# Springvale Mine Extension Project

## Review Report

June 2015

Figure 4: Mine Plan

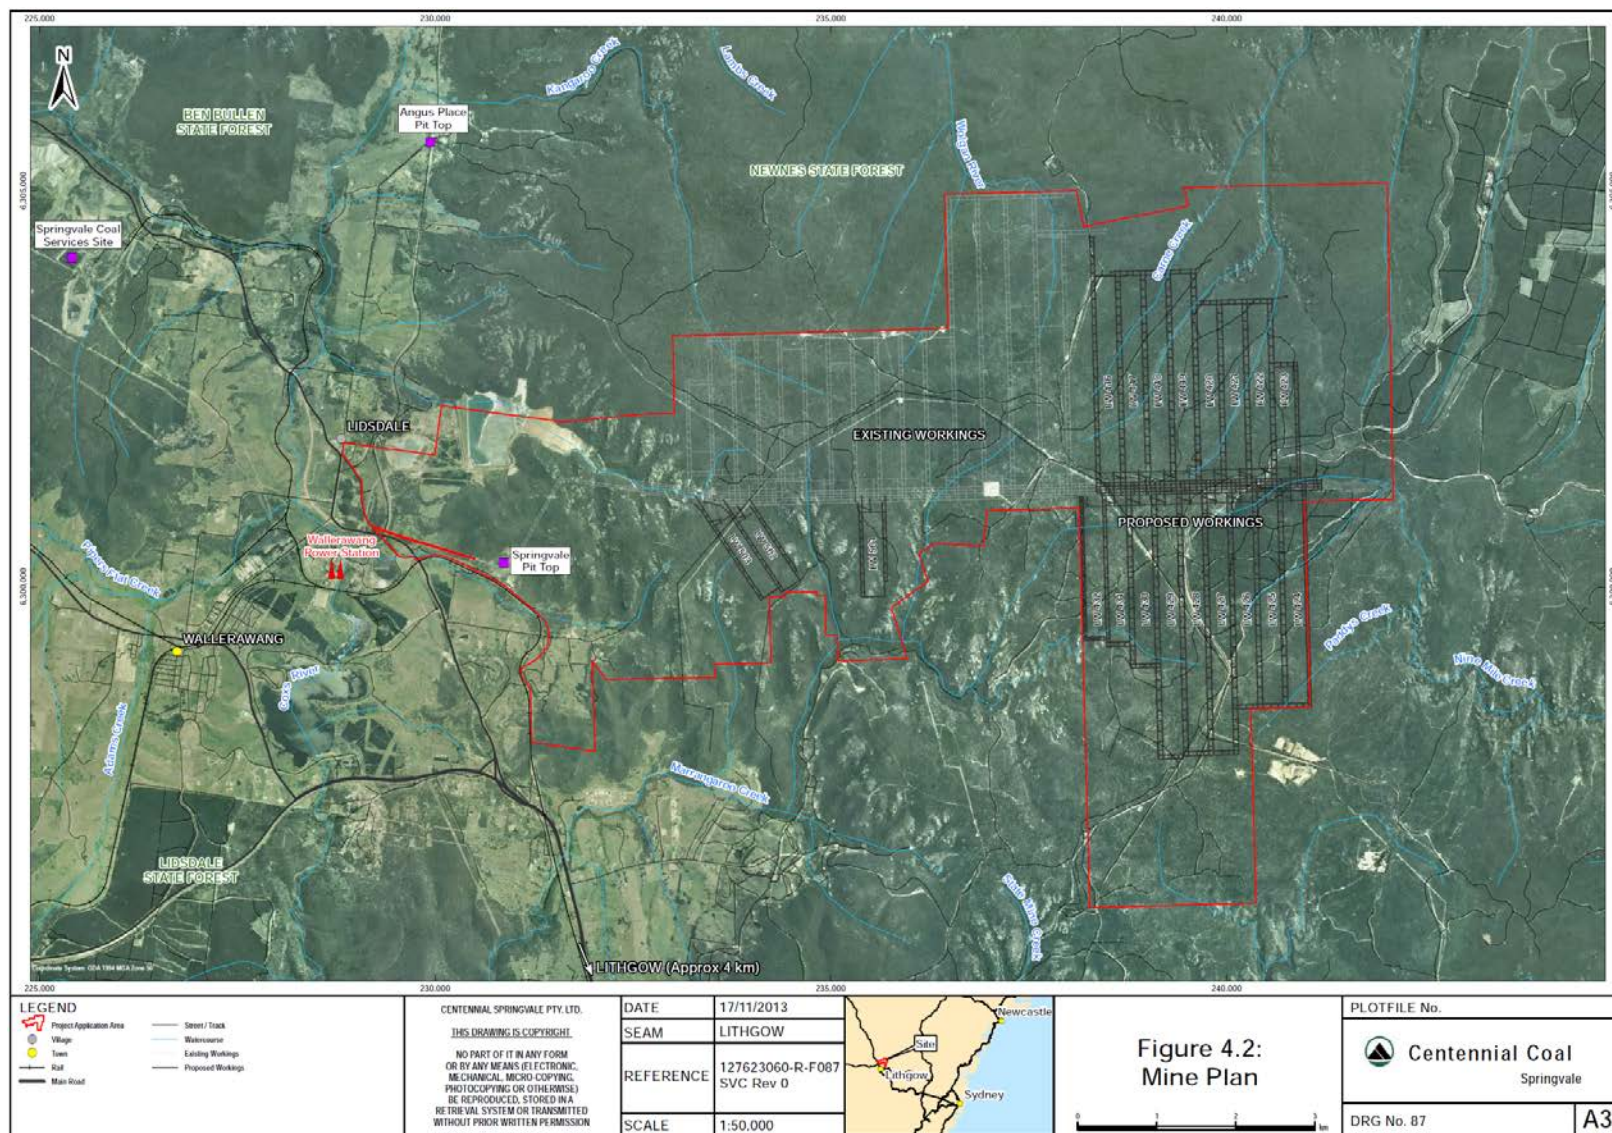
The Commission considers it important to note upfront that the layout of the proposed underground workings at the mine has been revised since the last development consent was granted and throughout the current development application process in an attempt to reduce predicted subsidence-related impacts. While the Applicant has an existing consent to extract coal from another five longwalls (LWs 419 to 423), the Commission understands that the Applicant has since significantly revised the mine plan by incorporating narrower longwall panel widths, wider chain pillars and some shortened panels. **Figure 4** shows the proposed mine plan.

These changes were based on previous experience at both the Springvale and Angus Place mines, which indicated that subsidence-related impacts on natural surface features may have been a result of high panel width-to-depth ratios. The key change is the reduction in the width-to-depth ratio of the longwalls from between 0.75 and 1 (i.e. ‘critical’ or ‘super-critical’), to between 0.65 and 0.75 (i.e. ‘sub-critical’). The Commission acknowledges that these changes project significant reductions in the amount of coal to be extracted by reducing the width of the proposed longwall panels from 350 metres to 260 metres, increasing the chain pillar widths to 58 metres, and shortening certain panels to avoid specific surface features.

While the Commission recognises that the Applicant's changes to the mine plan have reduced the potential financial benefits to the Applicant, it believes that such an approach is necessary to provide an appropriate balance between the protection of environmental assets and the recovery of economic benefits. Nevertheless, the Commission does not rule out the possible need for further refinements to the mine plan, in order to avoid, minimise or further mitigate potential environmental impacts (e.g. through adaptive management, as discussed in relation to swamps in **3.3.6**).

Figure 3.3 : Assumed Discharge and Salinity of Angus Place LDP001 in the Water Quality Model

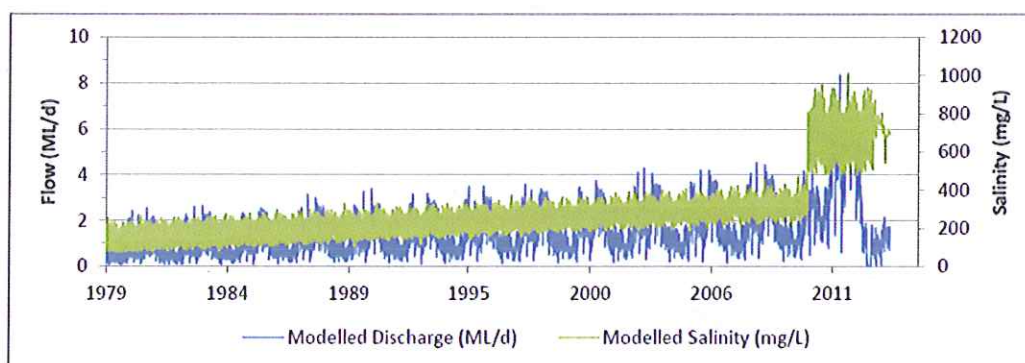
The median and maximum flows and total discharge limits stated in the EIS for Angus Place bear little resemblance to the assumptions used in the AWBM model. In the artificial "Assumed discharge" (Fig 3.3 in Jacobs (2015) reproduced above) the maximum discharge identified in the EIS (20.4 ML) does not even appear on the scale of the y-axis. The effects these assumptions about LDP001 flow and conductivity have on the model have not been adequately assessed.

Figure 3.9 : Calibration Time-Series Chart at #105 (Wangcol Creek above Western Coal Services, Gauge No. 212055)

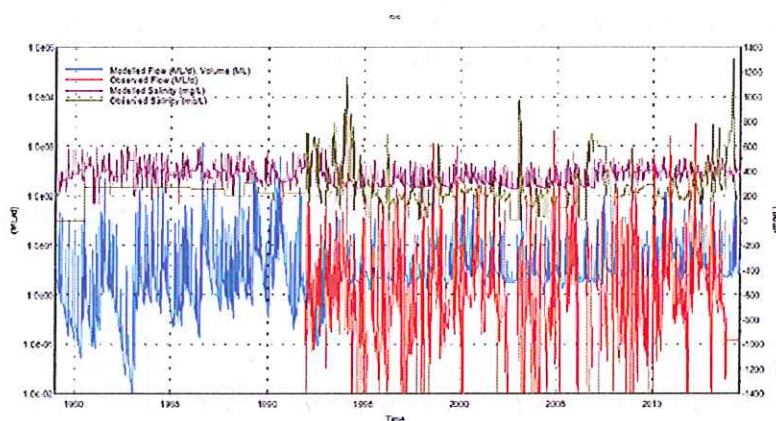
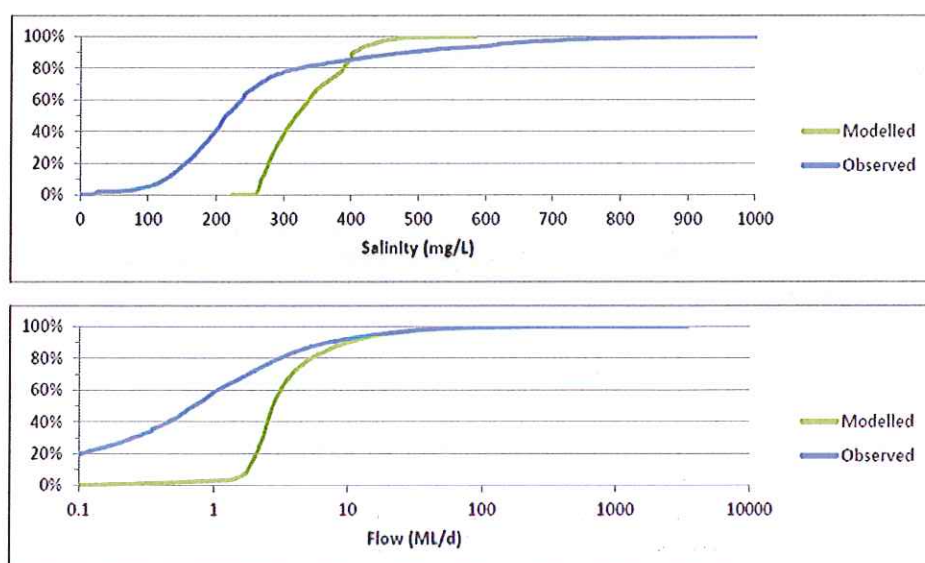
As identified earlier, comparison of observed data with modelled data for Neubecks Creek identify a very poor calibration (see Figure 3.9 in Jacobs (2015) reproduced below). The model predicts an average of around 3ML/day (median=2.7 in Table 3.5), whereas observed flows are usually 1 ML/day or lower (median=0.7 in Table 3.5). There has been no assessment of how these overestimates of flow affect model predictions downstream of the NOW gauge. It is equally clear that the model overestimates conductivity and there has also been no assessment of how overestimates in conductivity affect model predictions downstream of the NOW gauge (see Fig 3.10 reproduced below). Current and historic flows from Centennial's Lamberts Gully LDP (which discharges to Neubecks Creek) do not appear to have been included in the current AWBM assessment.

Figure 2. Flow at NOW Gauge 212054. Arrow highlights recent spike in flows likely to be a result of the LDP009 discharge.

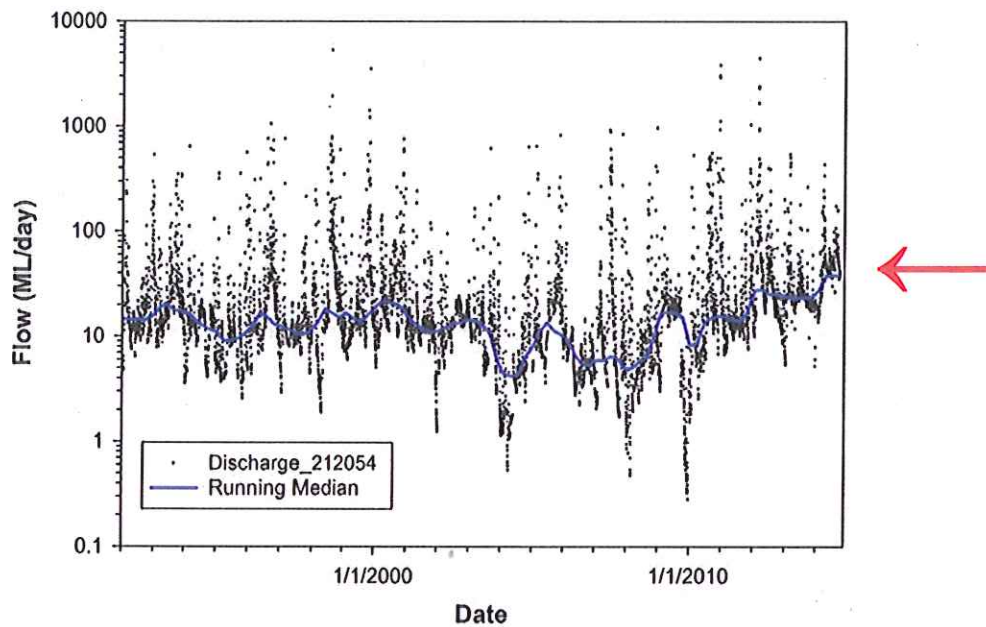
A plot of flows at the NOW 212054 gauge actually identifies a significant increase in flows in the most recent times, potentially as a direct result of the LDP009 discharge (Figure 2). This has still not been acknowledged or modelled appropriately in the AWBM assessment. A plot of Conductivity levels at the same Gauge also demonstrates a significantly increasing trend in Conductivity levels (ie an increasing salinization) of Upper Cocks River waters (Figure 3). This is most likely a result of the ongoing and increasing mine water discharges in the Upper Cocks River catchment but it too has not been identified or allowed for appropriately in the AWBM model. The failure of the report to address these two issues is considered a major flaw in the AWBM assessment.

Figure 3.72 : End of Pipe Target Time-Series chart at #047 (Coxs River above Lake Wallace, Gauge No. 212054) - Concurrent

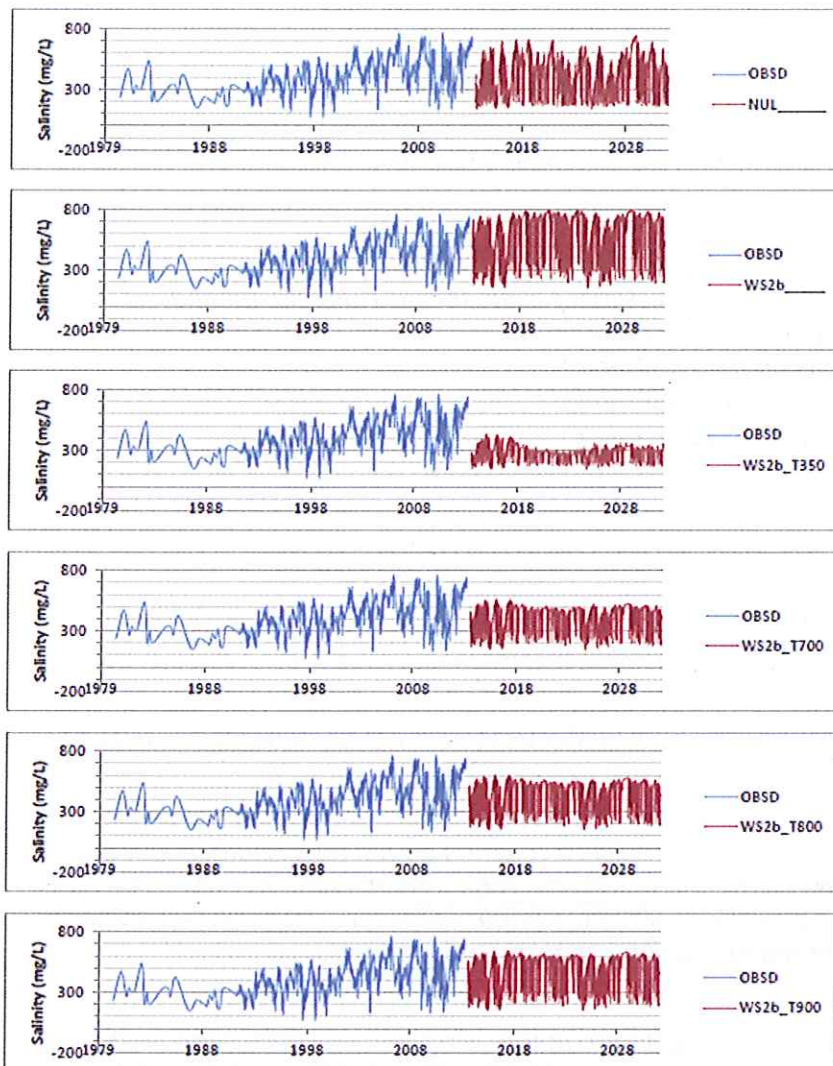
<sup>6</sup> As measured at the NOW gauge. It is emphasized that the model does not appear to adequately account for the recent rise in flow volumes or the increasing trend in conductivity measured at the NOW Gauge 212054 likely to be due in large part to the LDP009 discharge.
